Amphenol Canada Corp - Product Change Notice (PCN)

PCN Date	Dec.21,2021
Supplier Name:	Amphenol Canada Corp.
Amphenol Canada PCN Number	PCN-C2115
Description of Change	Remove CSA and UL logo on FGs of RJHSE, RJHSR, RJESE, RJSSE FRJAE and RJE01 series products. The shipping label remove CSA logo and remain UL logo.
Reason for Change	company policy request to remove CAS and UL logo on the parts.
Summary of changes between new and old part	Remove CSA and UL logo on FGs of RJHSE, RJHSR, RJESE, RJSSE FRJAE and RJE01 series products, it does not affect the overall form/fit/function of the connector.
Traceability guidelines (lot code / date code, markings, ship date...)	the new product will be controlled by dated code after confirmed the new sample: expected to cut in during date code 2110
Last Time Buy Date	N/A
Datasheet attached? & Filename(s)	RJHSE, RJHSR, RJESE,RJSSE and FRJAE series all part numbers. See next page for reference
Qual Test data attached? & Filename(s)	N/A

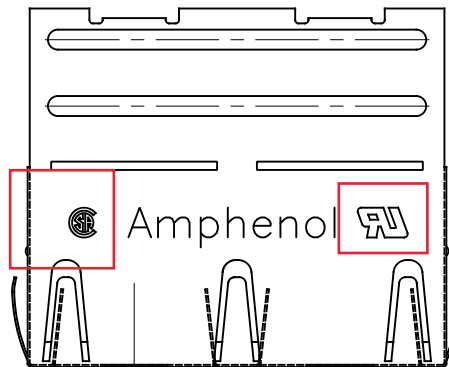
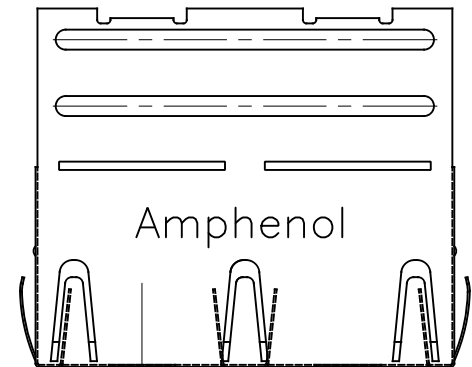
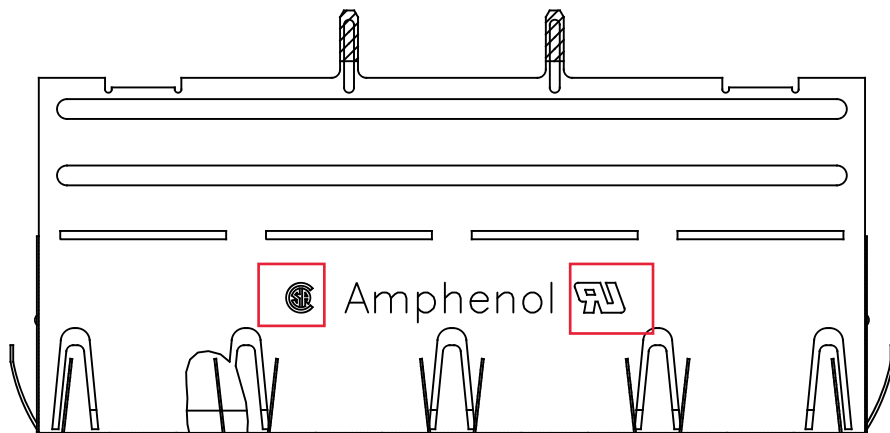
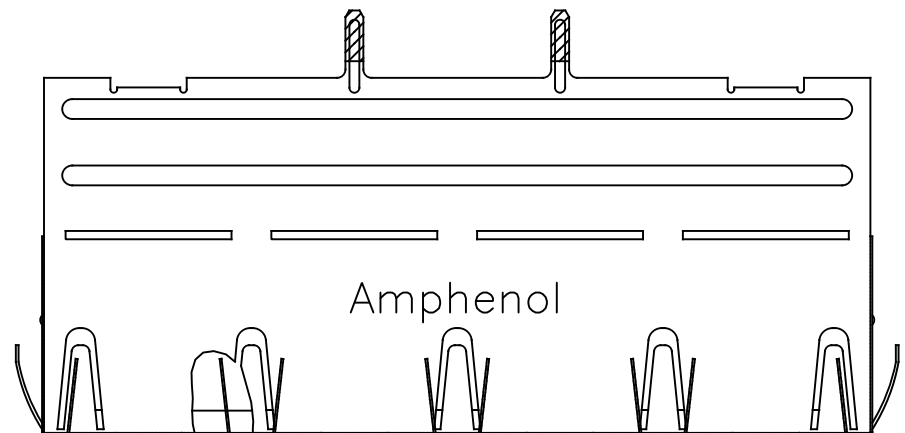
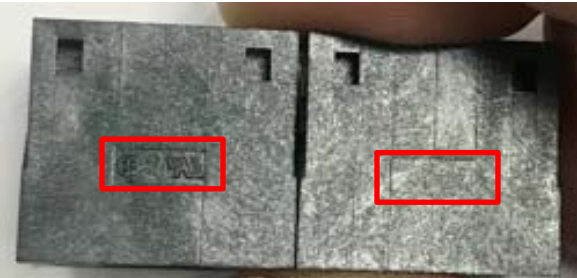
PCN Date	Dec.21,2021
Supplier Name:	Amphenol Canada Corp.
Amphenol Canada PCN Number	PCN-C2115
Description of Change	Remove CSA and UL logo on FGs of RJHSE, RJHSR, RJESE, RJSSE FRJAE and RJE01 series products. The shipping label remove CSA logo and remain UL logo.
Reason for Change	company policy request to remove CAS and UL logo on the parts.
Summary of changes between new and old part	Remove CSA and UL logo on FGs of RJHSE, RJHSR, RJESE, RJSSE FRJAE and RJE01 series products, it does not affect the overall form/fit/function of the connector.
Traceability guidelines (lot code / date code, markings, ship date...)	the new product will be controlled by dated code after confirmed the new sample: expected to cut in during date code 2110
Last Time Buy Date	N/A
Datasheet attached? & Filename(s)	RJHSE, RJHSR, RJESE,RJSSE and FRJAE series all part numbers. See next page for reference
Qual Test data attached? & Filename(s)	N/A
